CERTIFICATE OF APPROPRIATENESS

Property: 1204 Studewood Street, Lot 18, Block 127, North Norhill Subdivision. The property includes a 1,256 SF one-story wood frame duplex and a detached garage situated on a 5,000 square foot (50' x 100') interior lot.

Proposal: Alteration –

- The ceiling plate is proposed to be raised 1' to 9' (work completed without COA)
- One original front door opening to be changed to a window

3 EXIST. FRONT ELEVATION
SCALE: 1/4"=1'-0"

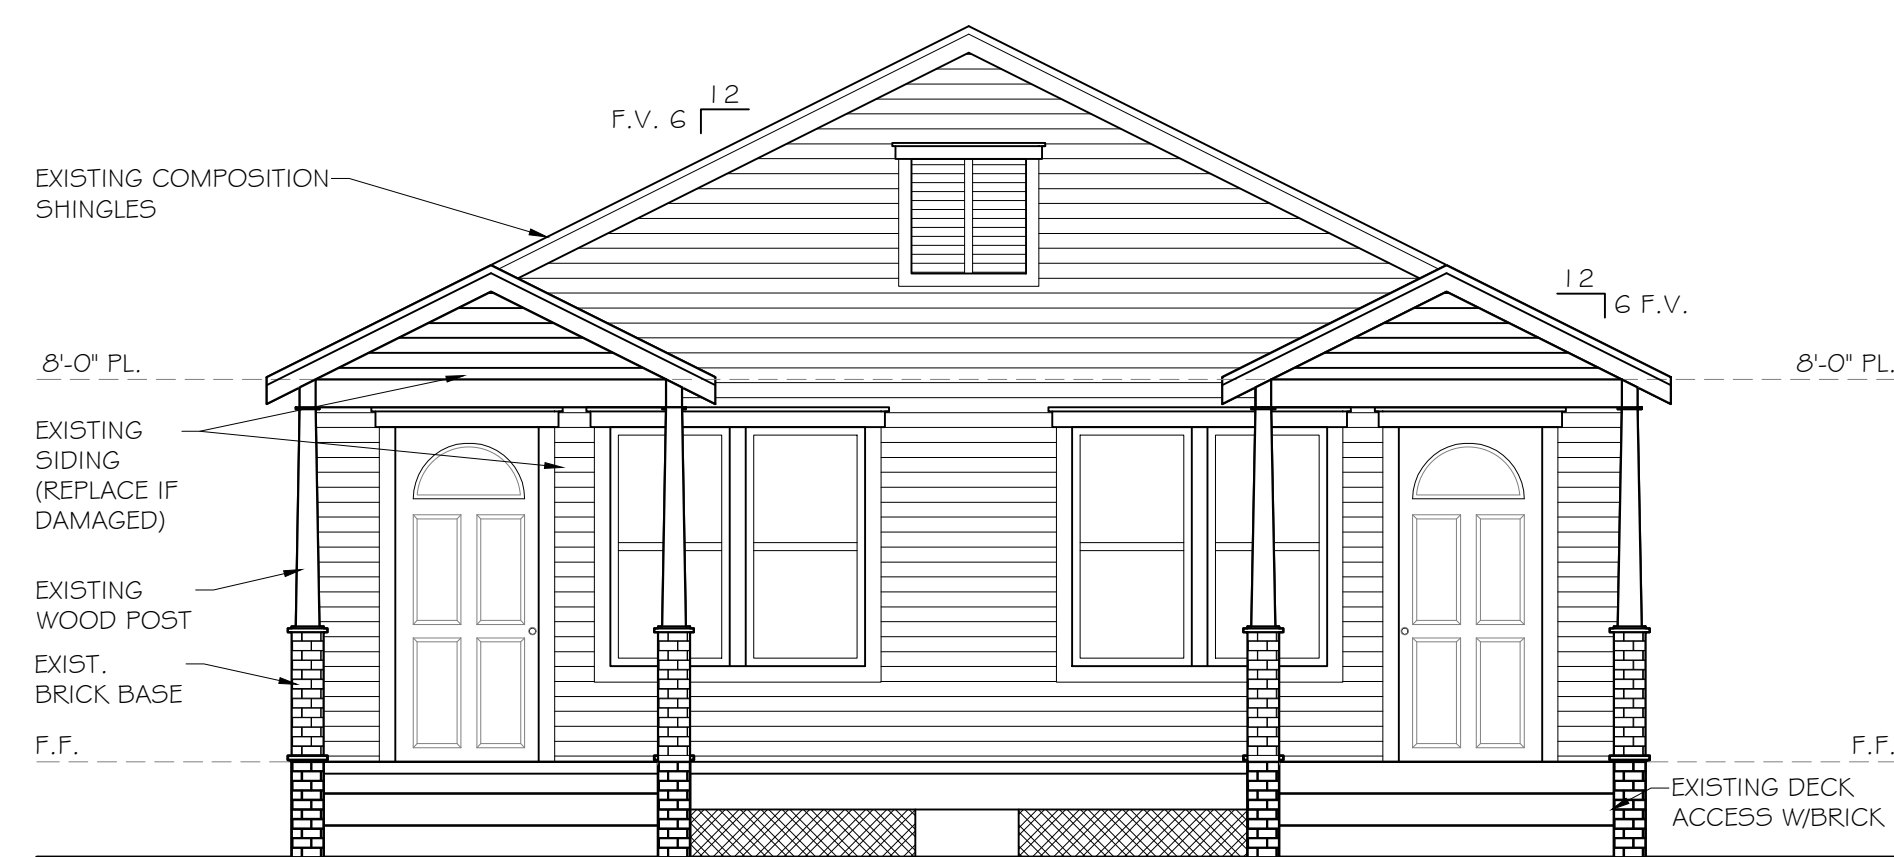
The elevation of the first-floor ceiling plate by approximately 1' while a not insignificant change; does not rise to the level of a change that eliminates any distinguishing qualities or characteristics of either the existing building or its environment. This is evidenced by the various proportional relationships between roof rafter tail ends to window tops throughout the context area. *The Field Guide to American Houses*, by McAlester, does not call out any proportional relationship between the length, height, or width of a walls and roof rafter tails or roof massing, as a distinguishing characteristic of a vernacular craftsman bungalow.

Existing doors and door trim are not original

Applicant proposes to replace inappropriate door with a craftsman style door

1 FRONT ELEVATION
SCALE: 1/4"=1'-0"

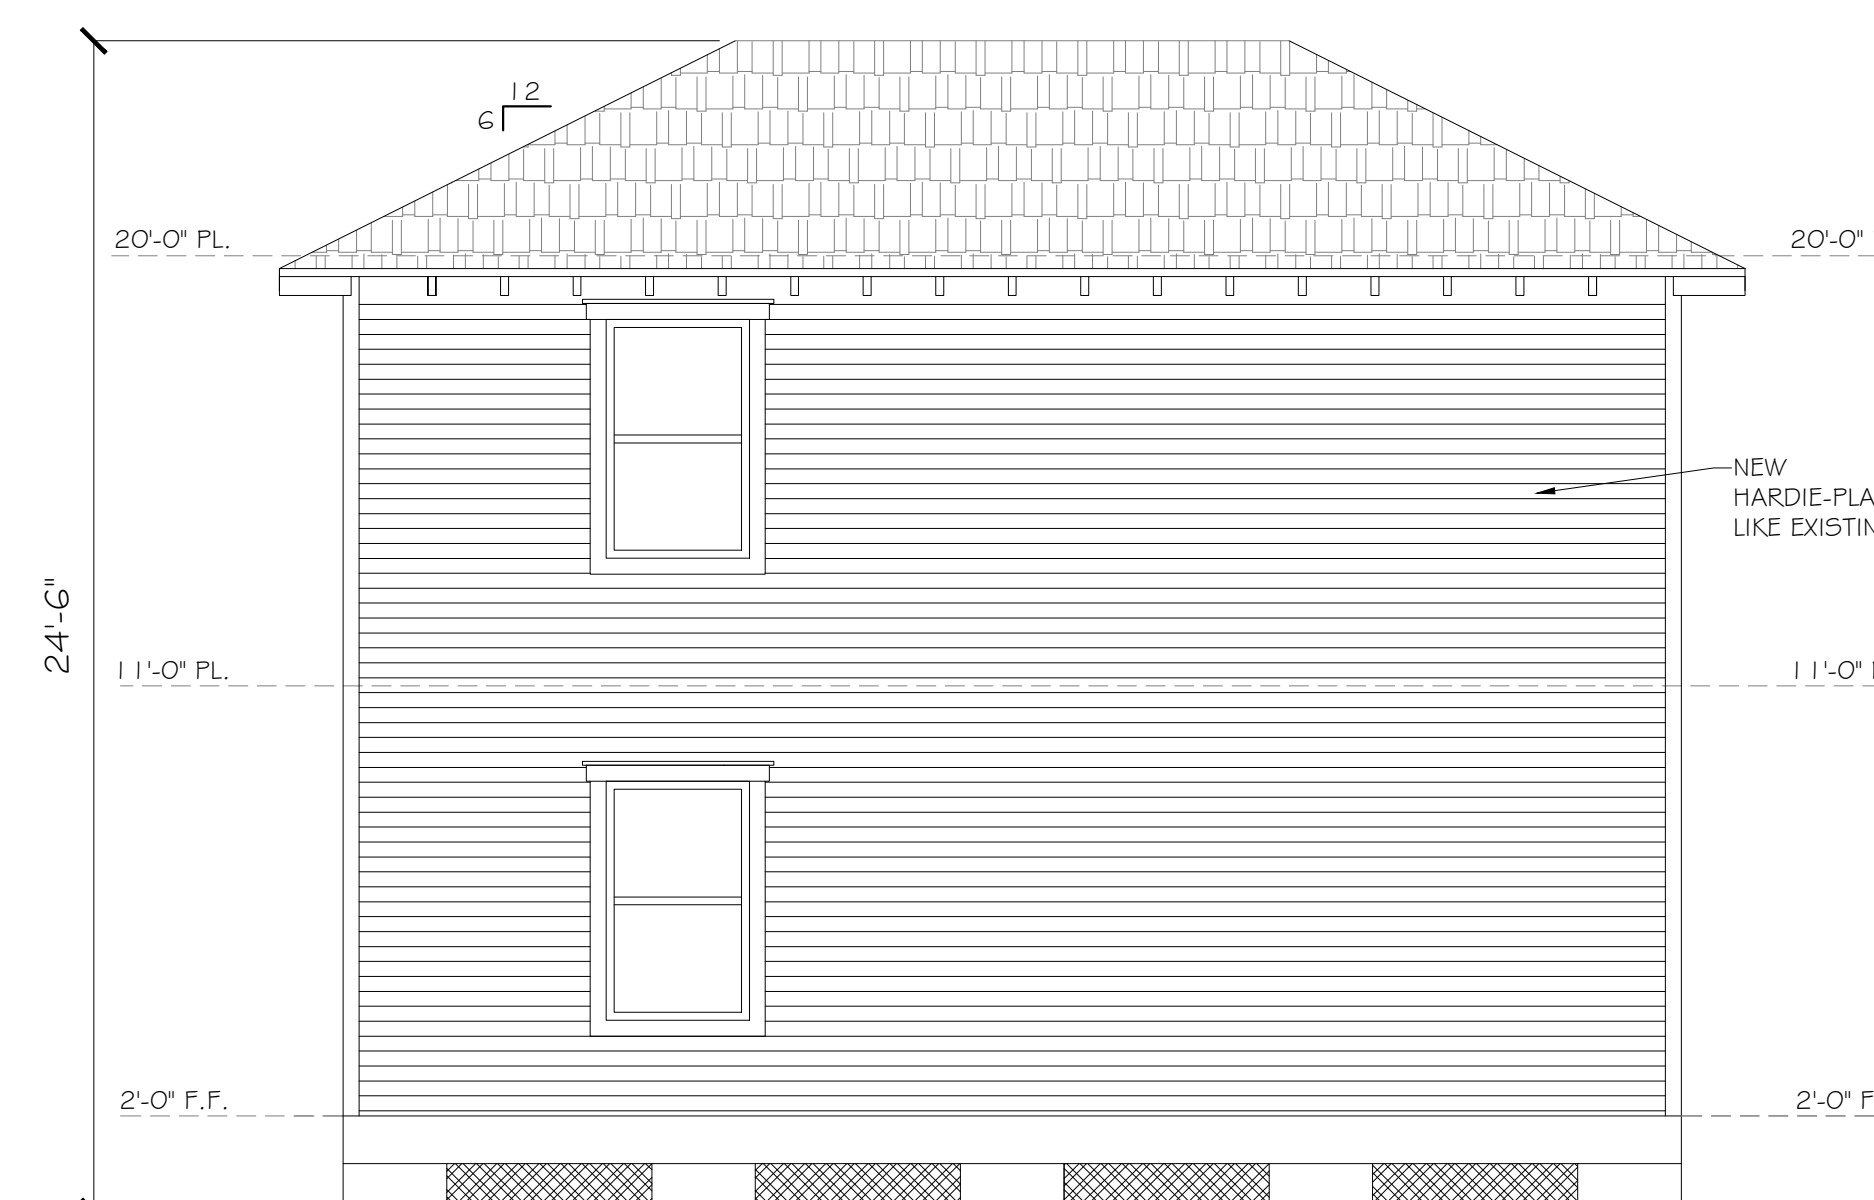
This building has been historically a duplex, or at least a double front and rear door building. At least two reasons exist to allow the one front door to be changed into a window. First, the draft Norhill Design Guidelines specifically allow for this. The draft document has gone through rigorous public input. Second, the front entry doors and trim have been changed to contemporary materials. The replacement of a door with a window does not require the removal of original material. If the appearance of a second door defines the building, then a more owner friendly resolution would be to retain the opening with solid infill and re-install appropriate trim.

This full project was presented at the September 2022 meeting. The decision was to issue a COR allowing for the addition and the new single car garage but denying elevation of the ceiling plate (it should be returned to original height) and requiring that both front doors to be retained and functioning, no alteration to the front porch.
